## Addendum #1

Re: **Addendum No. 1**  
Cary Main EMS  
819 Kildaire Farm Road  
Cary, NC 27511  
ADW Job No. 21046  
Wake County Bid #24-086

These clarifications constitute Addendum No. 1 and considered part of the Bid Documents. General Contractor shall see that their sub-contractors are in full receipt of the information contained herein.

**SECOND FLOOR  
ELECTRICAL  
POWER PLAN**

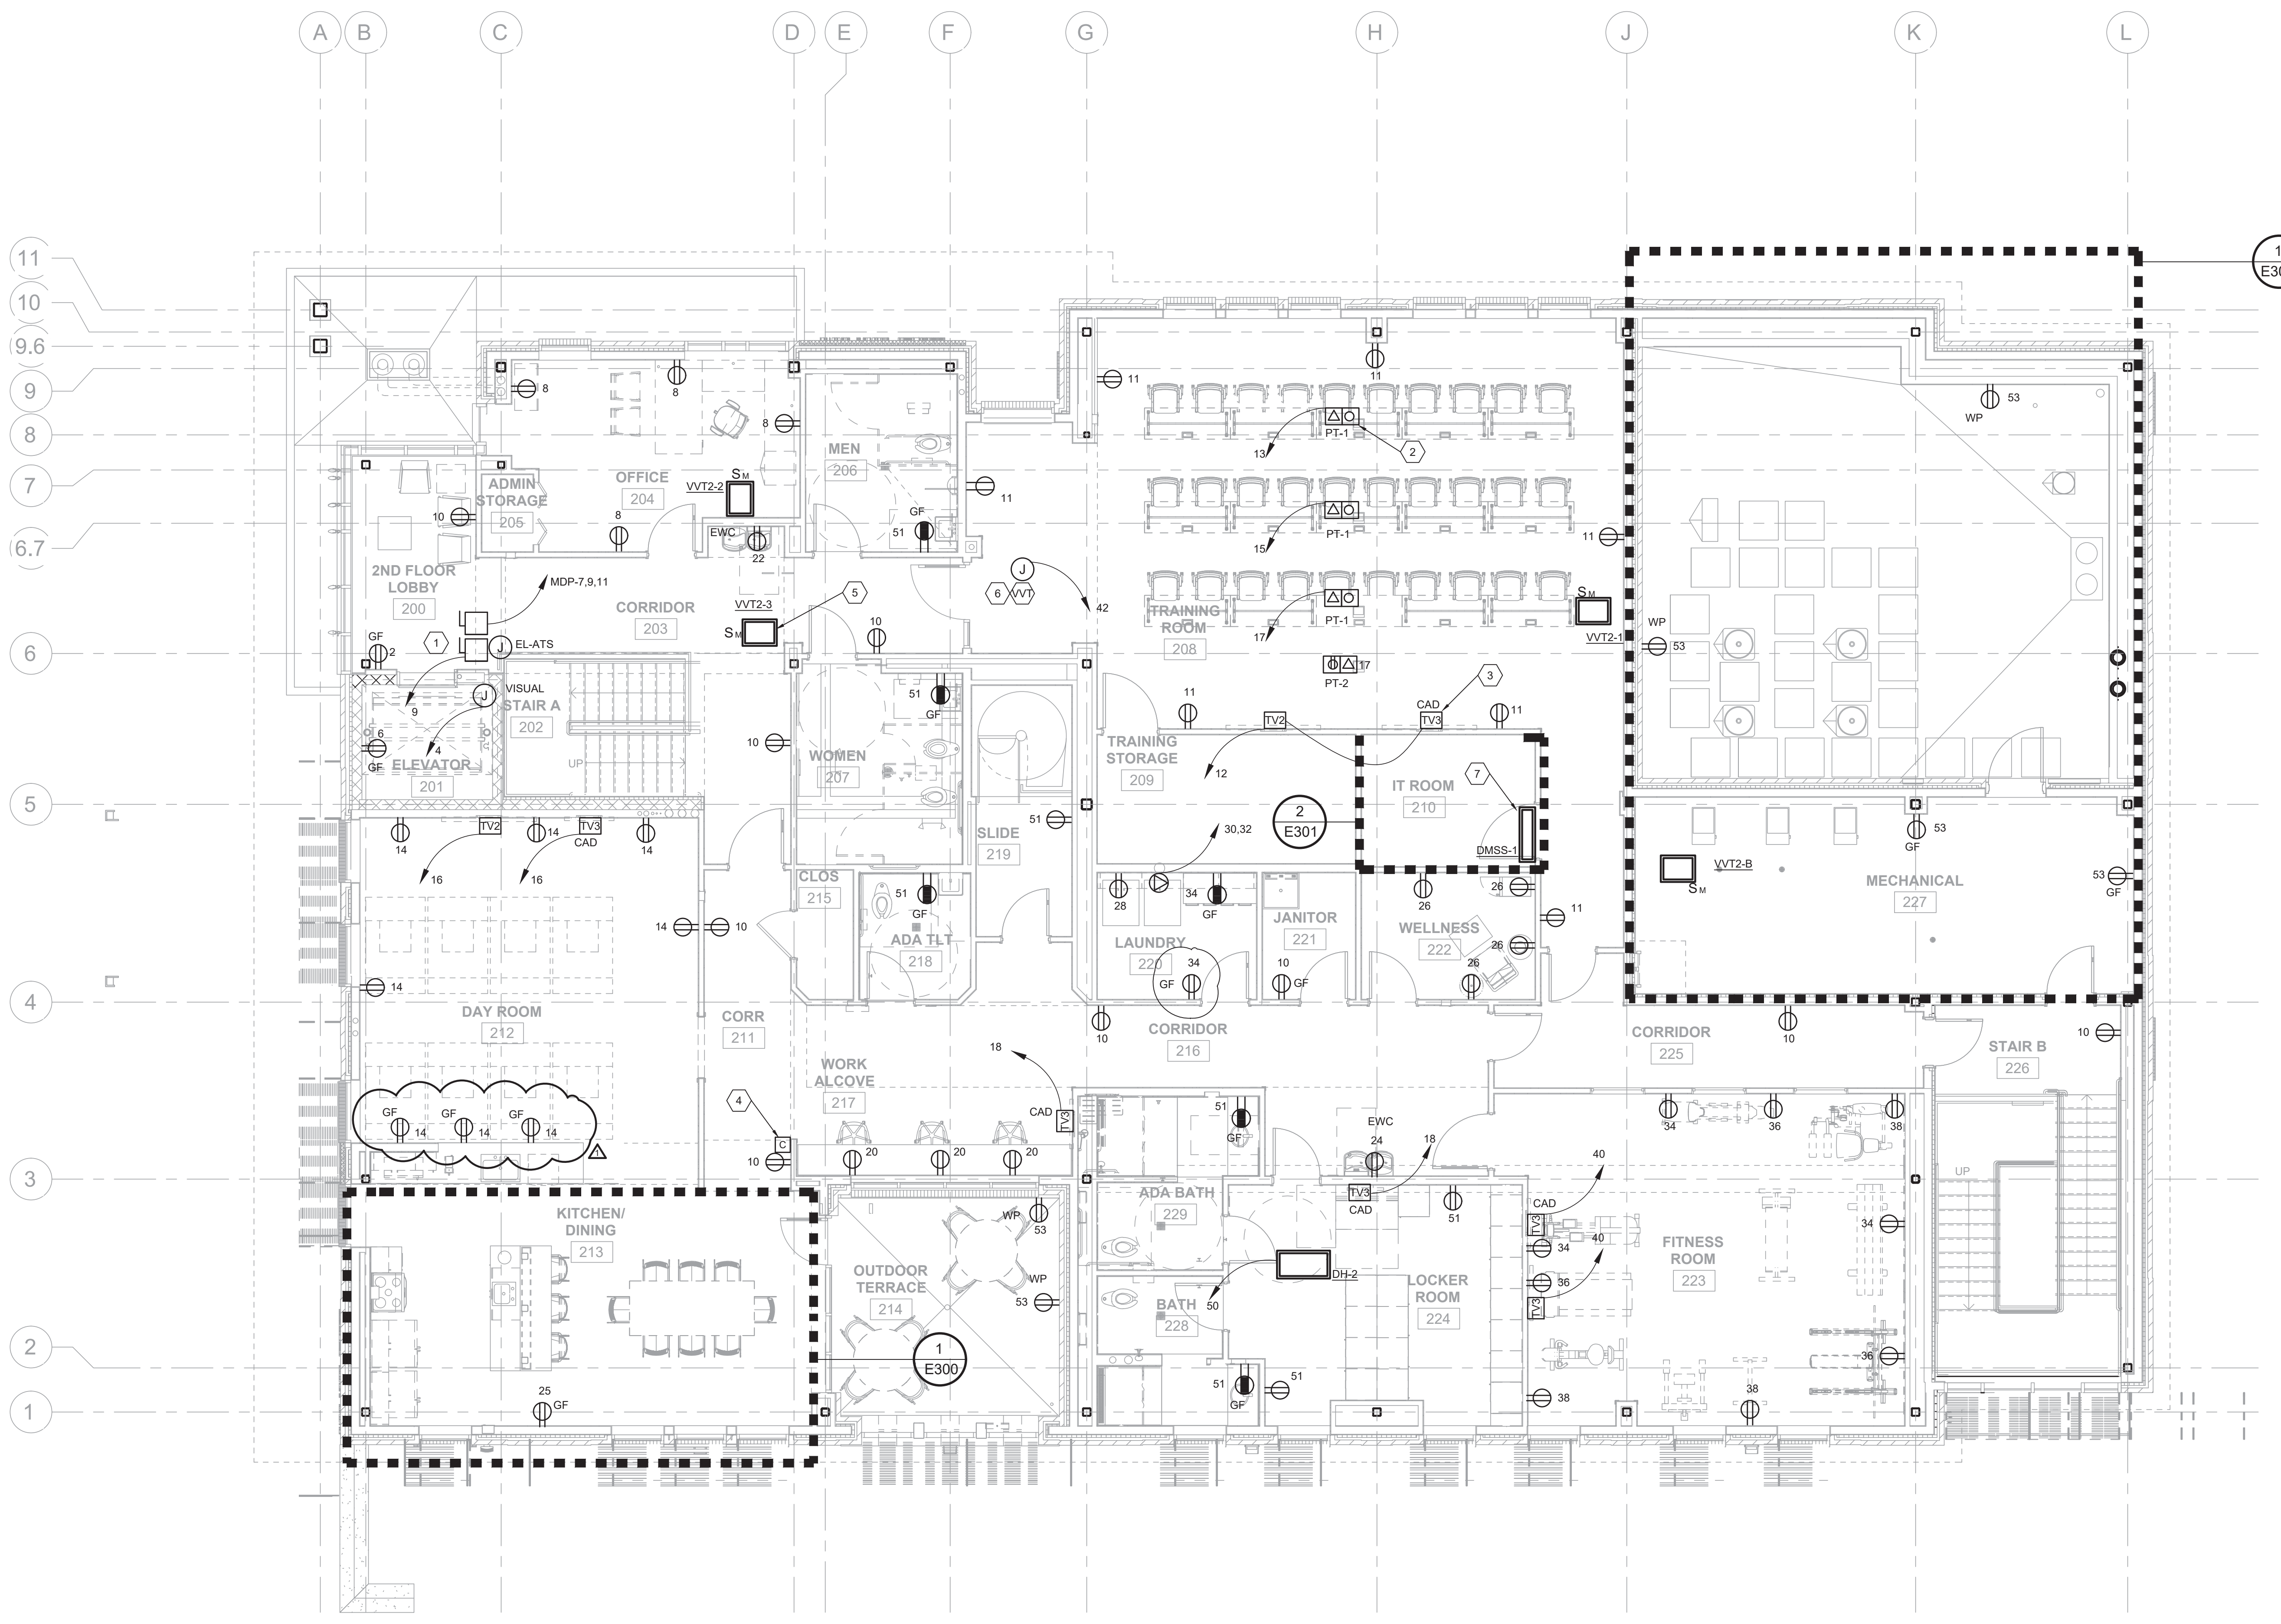
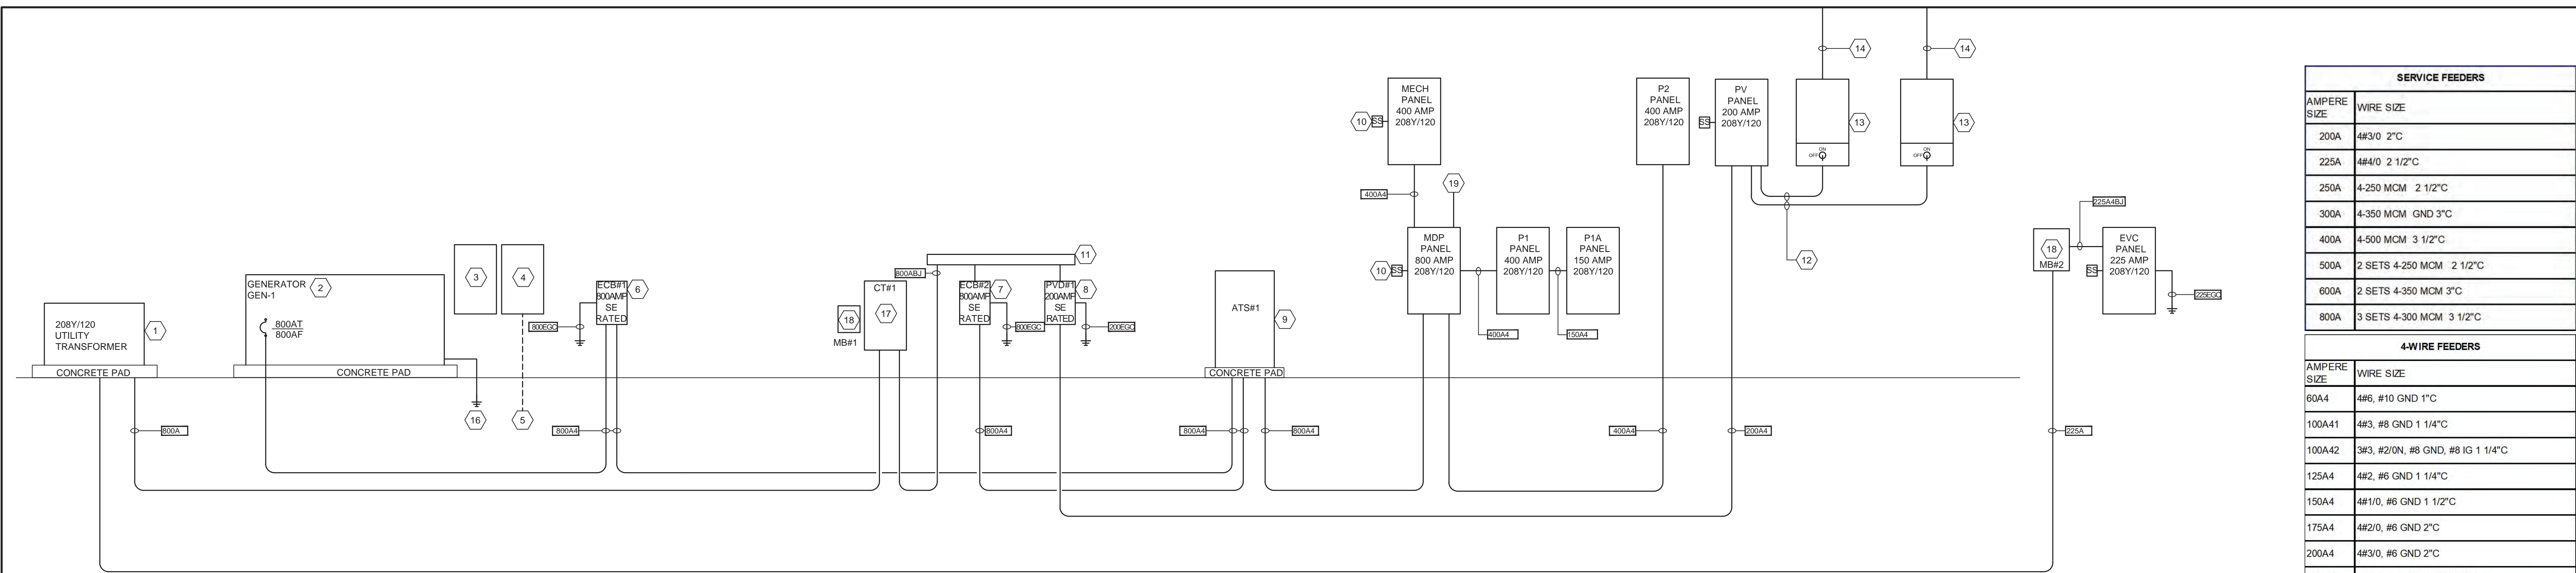
- 1.) Sheet E212: See attached revised sheet for revision of outlets to GF at dayroom 212 per permit comment.
- 2.) Sheet E400: See attached revised sheet for revision at panel P1 per permit comment.
- 3.) Sheet E501: See attached revised sheet for added note on detail 3/E501 per permit comment.
- 4.) Sheet E502: See attached revised sheet for revised note on detail 3/E502 per permit comment.
